South Texas Project
Units 3 and 4
Docket Nos. 52-012 and 52-013
Supplemental Response to Request for Additional Information

RAI 03.07.01-27, Supplement 4

RAI 03.07.01-27, Supplement 4**QUESTION:****Follow-up Question to RAI 03.07.01-19 (STP-NRC-100093)**

Figure 3H.6-212: Lateral Seismic Soil Pressure (psf) on RSW Piping Tunnel East Wall (Main Cross Section of RSW Piping Tunnel)

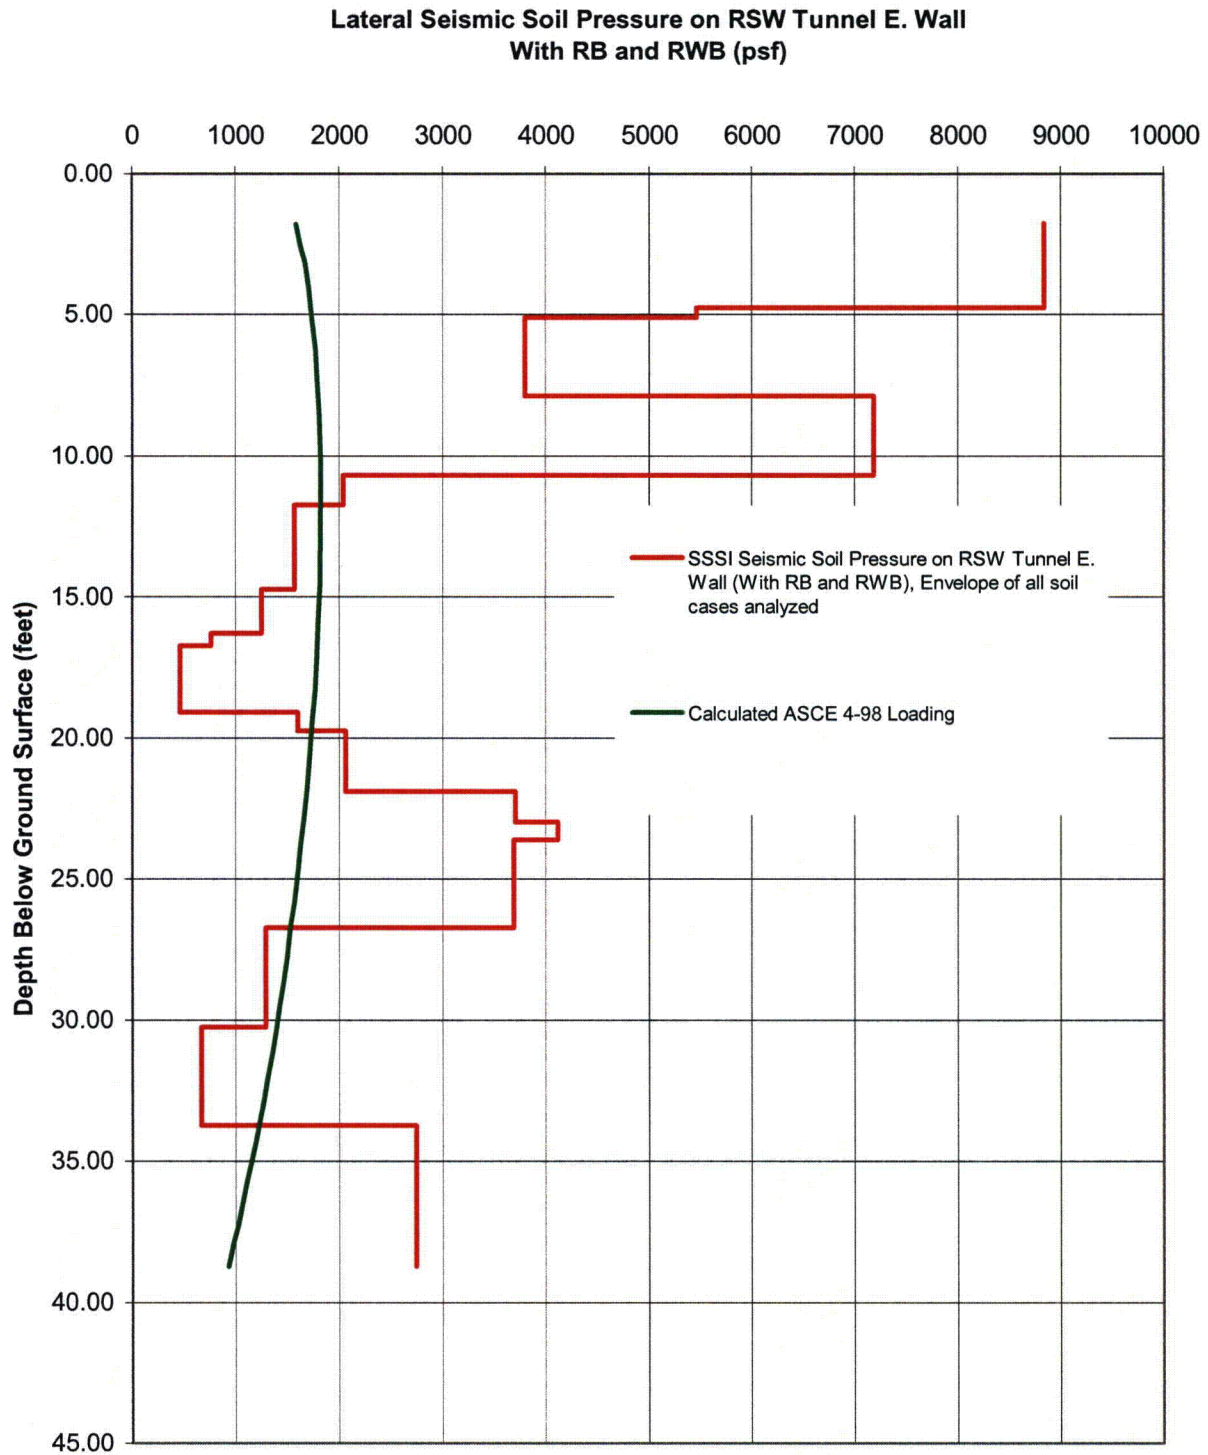
- b. *The COLA will be revised to refer to Figures 3H.6-212 through 3H.6-217 for RSW Piping Tunnel design (Audit Action Item 3.8-32, Punch List Item 80)*

See COLA mark-up for Section 3H.6.4.3.3 shown in the Enclosure. Also included in the Enclosure are additional clarifications for Sections 3H.6.2, 3H.6.4.3.1.4 and 3H.7.4.3.1.3.

Figure 3H.6-218: SSI, SSSI, ASCE 4-98 and Design Lateral Seismic Soil Pressures on RSW Pump House South Wall

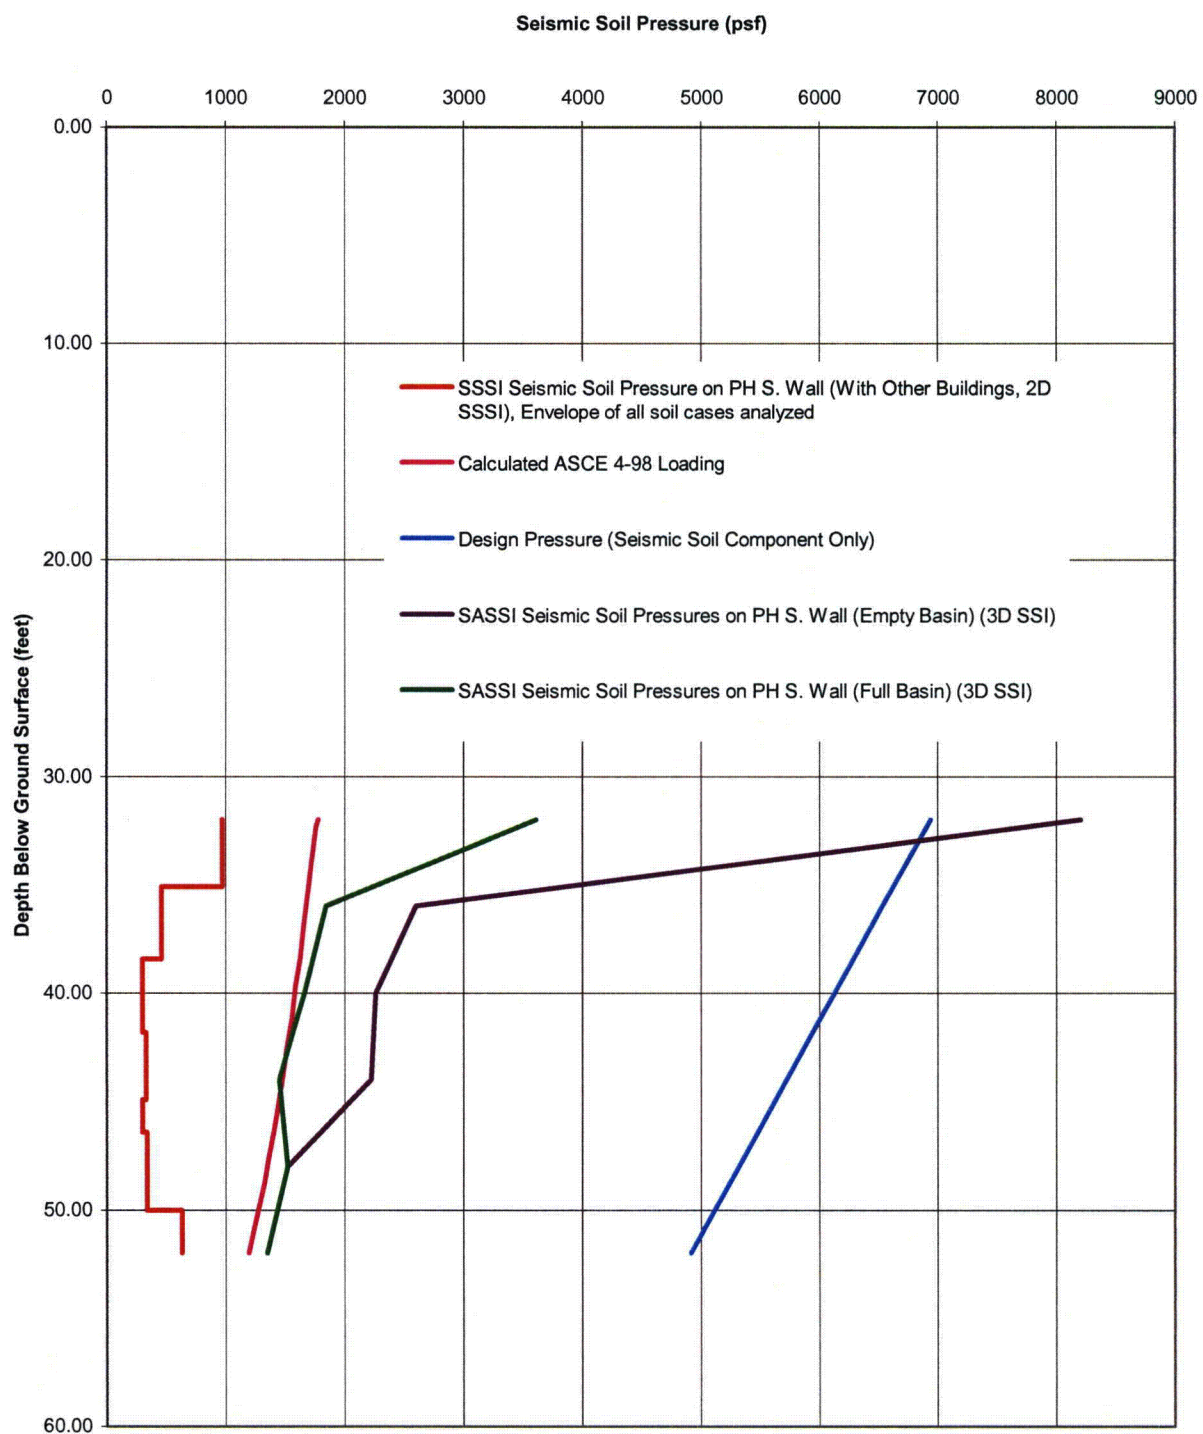
- c. *Revise Figure 3H.6-219 to remove 2D 'Alone' soil pressure profile. Also revise the figure to provide seismic pressure profile used for design in lieu of static + dynamic. Also check other figures for the same issues (Audit Action Item 3.7-42, Punch List Item 87)*

See revised soil pressure figures provided in the Enclosure. These revised figures replace the previous figures (with the same figure numbers) in entirety.
